PROPOSAL TO STANDARDS COMMITTEE

REVISION TO 2024 STANDARD SPECIFICATIONS AND STANDARD DRAWINGS

E 609-RCBA-04 REINFORCED CONCRETE BRIDGE APPROACH SECTION, PAVEMENT LEDGE, AND BAR BENDING DETAILS (shown markups)

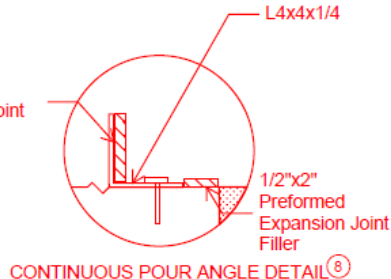
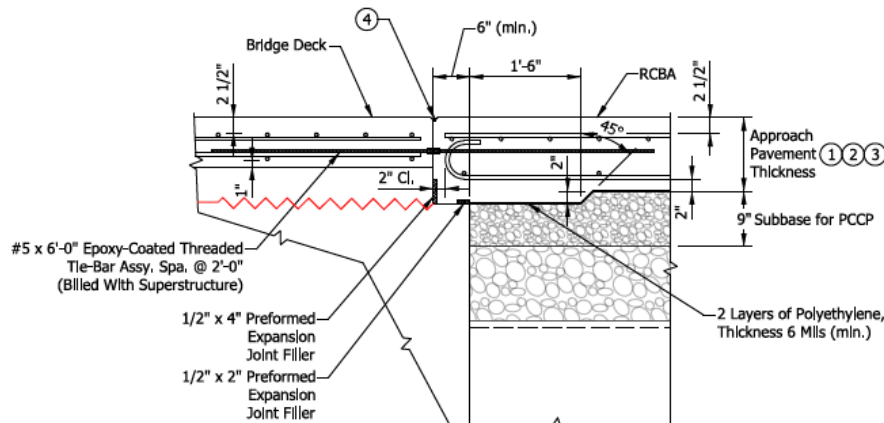
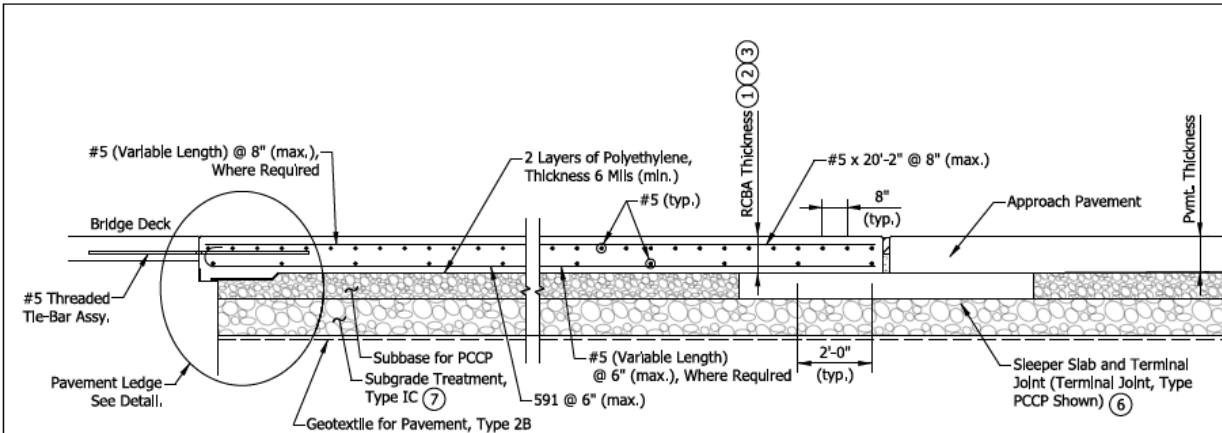
- ⑦ When the RCBA is constructed without a terminal joint, subgrade treatment shall be omitted and geotextile shall be placed under subbase for PCCP.
- ⑧ When the RCBA is poured continuous with the bridge deck, a contiguous angle shall be mechanically fastened to the full length of the pavement ledge using galvanized or stainless steel fasteners.

Preformed Expansion Joint Filler shall be secured to the angle and pavement ledge as shown. The angle material shall be ASTM A709, Grade 36 and galvanized in accordance with ASTM A123. When the RCBA is poured after the pavement ledge has been constructed, the angle shall be omitted and the Preformed Expansion Joint Filler shall be secured to the pavement ledge and bridge deck as shown.

E 609-RCBA-04 REINFORCED CONCRETE BRIDGE APPROACH SECTION, PAVEMENT LEDGE, AND BAR BENDING DETAILS (draft)

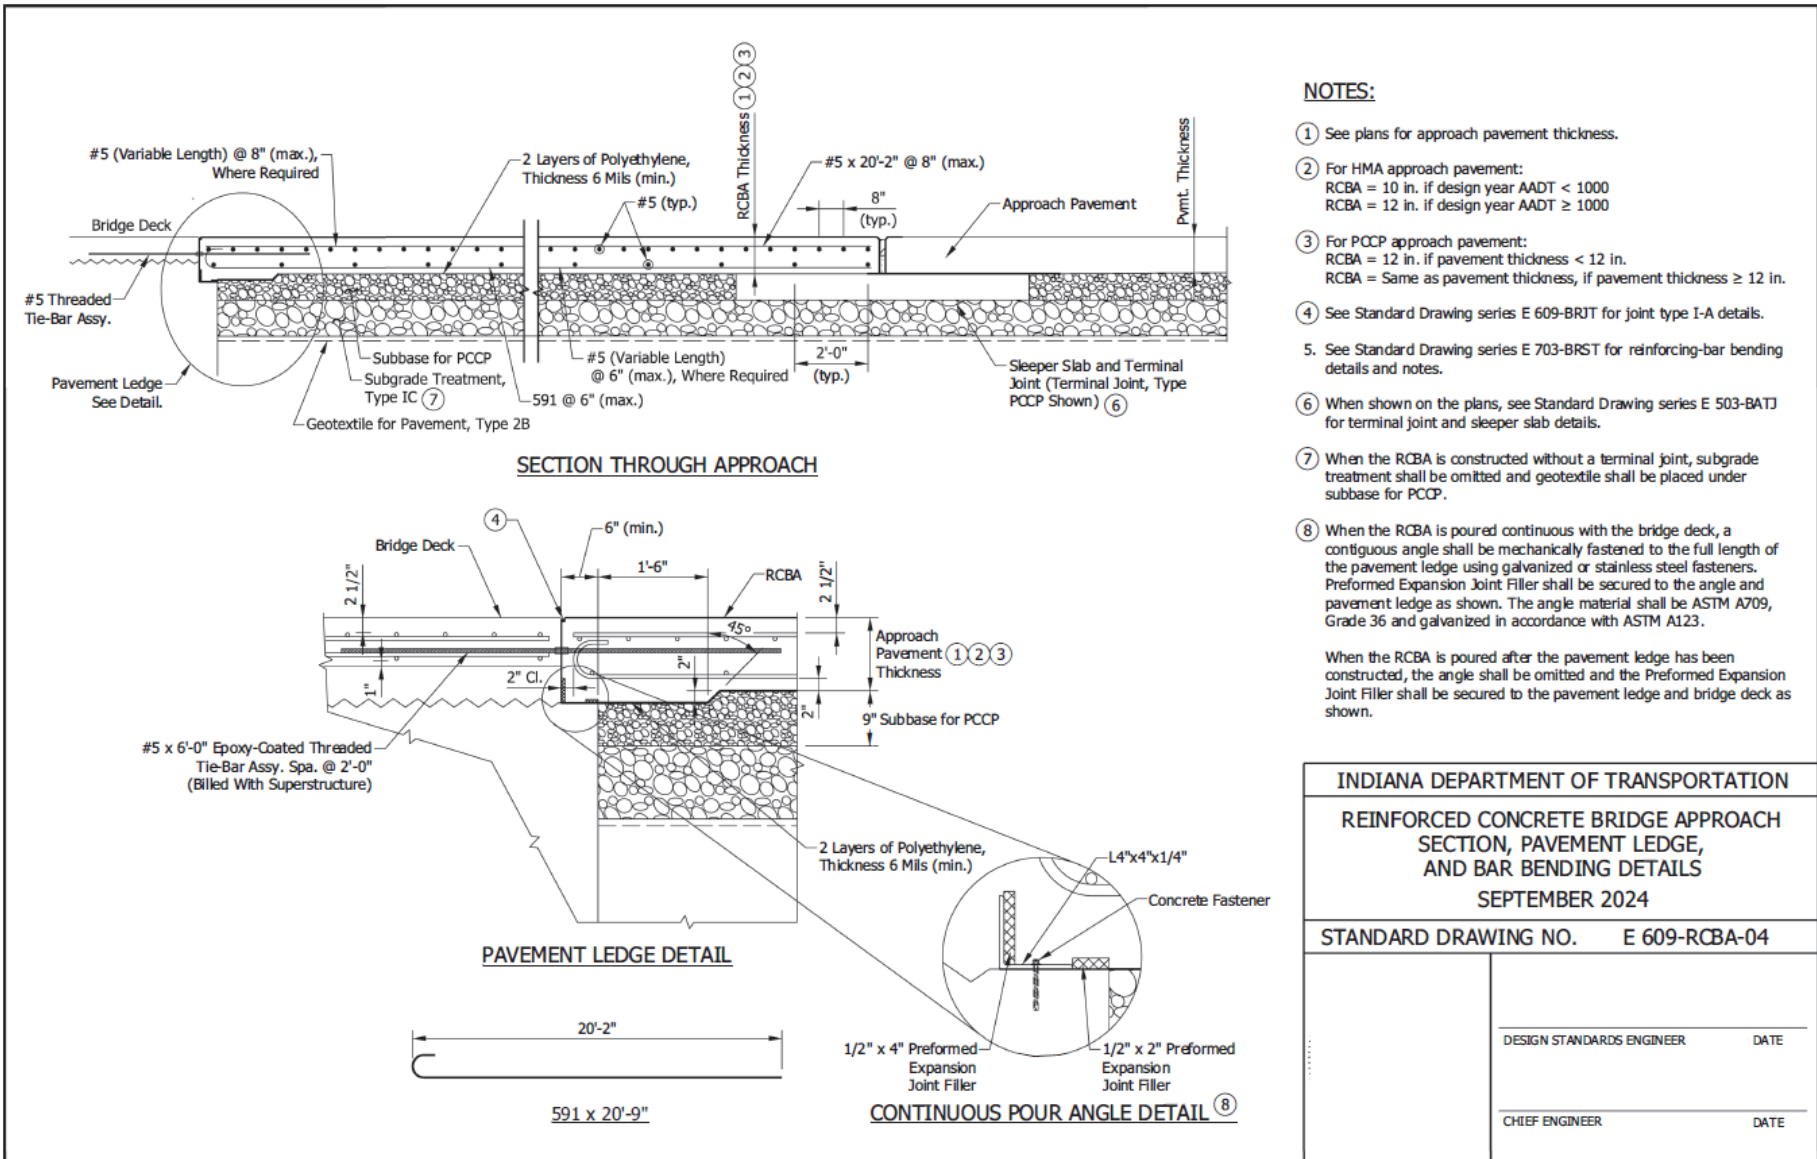
- ⑦ When the RCBA is constructed without a terminal joint, subgrade treatment shall be omitted and geotextile shall be placed under subbase for PCCP.
- ⑧ When the RCBA is poured continuous with the bridge deck, a contiguous angle shall be mechanically fastened to the full length of the pavement ledge using galvanized or stainless steel fasteners. Preformed Expansion Joint Filler shall be secured to the angle and pavement ledge as shown. The angle material shall be ASTM A709, Grade 36 and galvanized in accordance with ASTM A123.

When the RCBA is poured after the pavement ledge has been constructed, the angle shall be omitted and the Preformed Expansion Joint Filler shall be secured to the pavement ledge and bridge deck as shown.
